**AGENDA
BOARD OF ADJUSTMENT
REGULAR MEETING
DECEMBER 18, 2024
5:00 PM
CITY HALL COMMISSION CHAMBERS
204 ASH STREET
FERNANDINA BEACH, FL 32034**

Project Type	Site Plan Review
Project Name	3rd and Beech Multifamily Condo
Proposed Access Road	Beech Street and South 4th
Rd Maintenance Jurisdiction	City Maintained
Project Estimated Cost	350000
Description of Request	Construction of 2 (two) two-story triplex units and a four-story, 29-unit residential condominium and apartment building
Site Plan Review Checklist	<i>Field not completed.</i>
School Concurrency	<i>New residential development is required to demonstrate compliance with school concurrency as regulated in the City of Fernandina Beach through the City of Fernandina Beach's Comprehensive Plan Intergovernmental Coordination Element and the Interlocal Agreement Amendment for Public School Facility Planning adopted by the City on May 21, 2019. No new residential rezoning, preliminary plat, site plan or functional equivalent may be approved by the City unless the residential development is exempt from requirements outlined in Section 9.13 of the Amended Interlocal Agreement OR a School Concurrency Reservation Letter has been issued

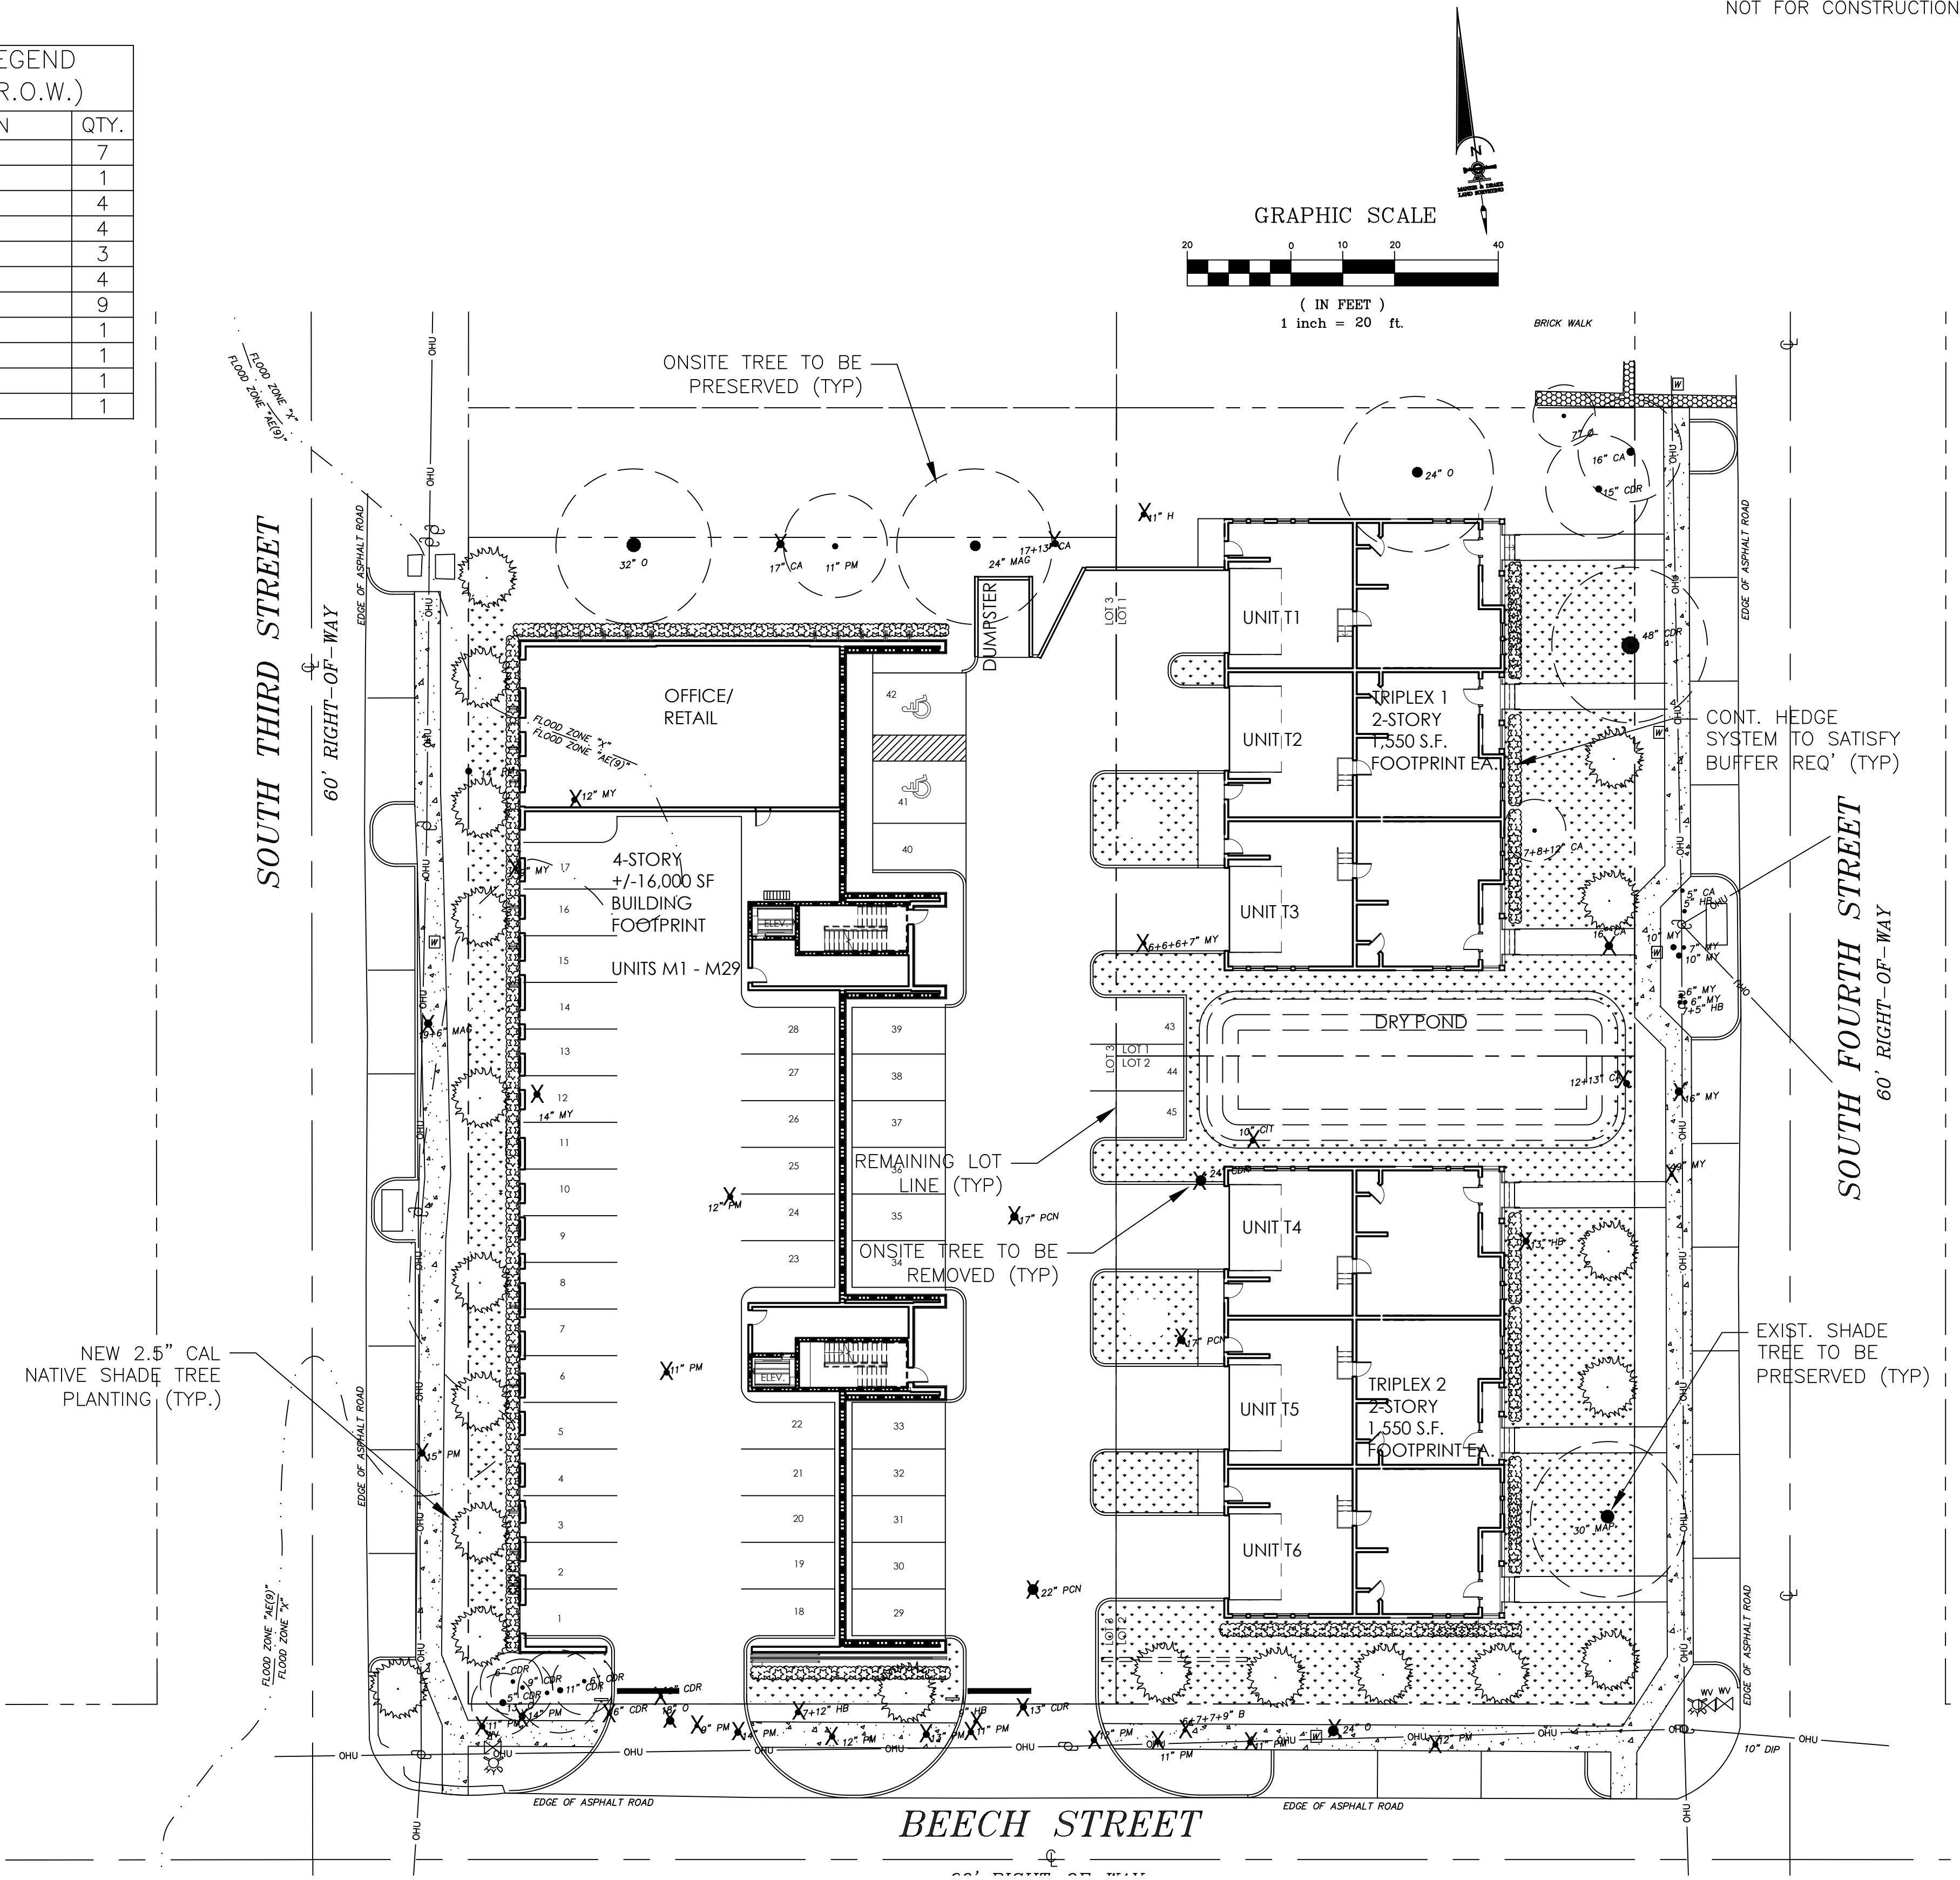
Landscape Details: Add 15 ft dimensions for Buffers on Landscape Plan (LS-1), it appears compliant, but the detail is needed to ensure this along with the minimum planting requirement is achieved. With respect to the buffer between MU-1 and R-2, please provide a letter consistent with 4.05.13 and document how the site achieves the buffer minimums in alternate planting locations. Please incorporate additional tree planting with appropriate planting materials in larger internal islands located at the rear of the triplex structures.
